SUNDRY NOTICES AND REPORTS ON WELLS

8. Well Name and No.
GISSLER B 38

DRILLING PLAN
Gissler B 38 Deepening

Gissler B 38
30-015-34359
Burnet Oil Co.
June 03, 2014
Conditions of Approval

Burnett Oil Company

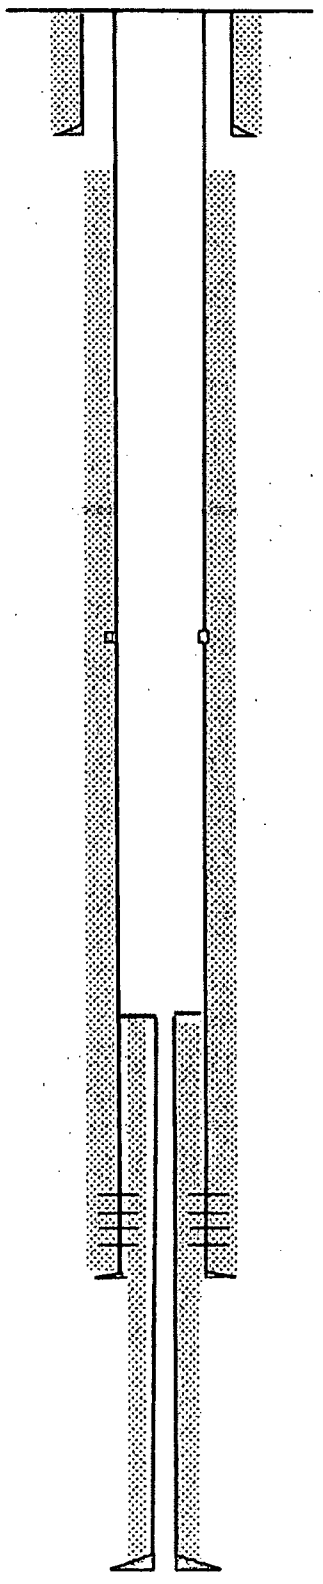
9 5/8" @ ~~420~~ 413' ← 44-3/4" per completion report
in 12 1/4" hole
Cemented w/600 sx 205 sx Top Out

Squeeze perfs with 300 sx before deepening

1. Work to be complete within 180 days.
2. Surface disturbance beyond the existing pad requires prior approval.
3. Closed loop system to be used.
4. H2S monitoring equipment should be onsite for personnel protection from surrounding oil operations. Operator should not encounter H2S while deepening.
5. BOP to be tested to **2000 psi** based on BHP expected.
6. Variance for stand-off of less than 0.422" is approved due to NMOCD classifying the formations in this area as the Yeso group.
7. Cement on liner shall tie back to liner top, if this is not achieved contact appropriate BLM office. When plugged, cement plug will be required across this tie back and across squeezed perforations.
8. Test casing as per Onshore Order 2.III.B.1.h.
9. Subsequent sundry detailing work and current well test data are to be submitted when work is complete.
